From: Francis Pullaro, Executive Director, RENEW Northeast

Date: March 15, 2022

Subject: Feedback on Analysis Group's Draft Pathways Study Report

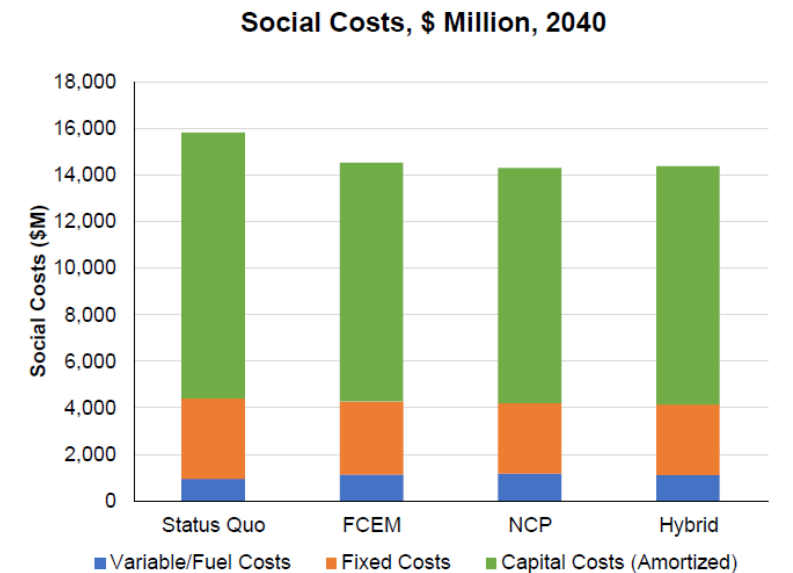
We find it hard to discern to what extent the study’s findings, particularly that the Status Quo case results in higher cost than the market based cases, are driven by the assumption that future state procurements will not stray from the previously developed roadmaps and how much they are driven by the nature of the procurements themselves.

We believe that a figure providing a breakdown of social costs by capital costs, variable/fuel costs, and fixed costs, as were presented at past Participants Committee meetings, will begin to help explain these differences.

1. A qualitative explanation of how the Status Quo assumption regarding which resources are procured impacts the results and that if state procurements were to diverge from the roadmap assumptions the cost difference between the Status Quo and other cases could change.
2. Inclusion of the figure and description of the breakdown of Social Costs by Variable Costs, Fixed Costs and Capital Costs, as was included in previous AG presentations on the results of the study (see Analysis Group’s presentation to the Participants Committee on December 6, 2021 slide 14, figure copied below for reference)
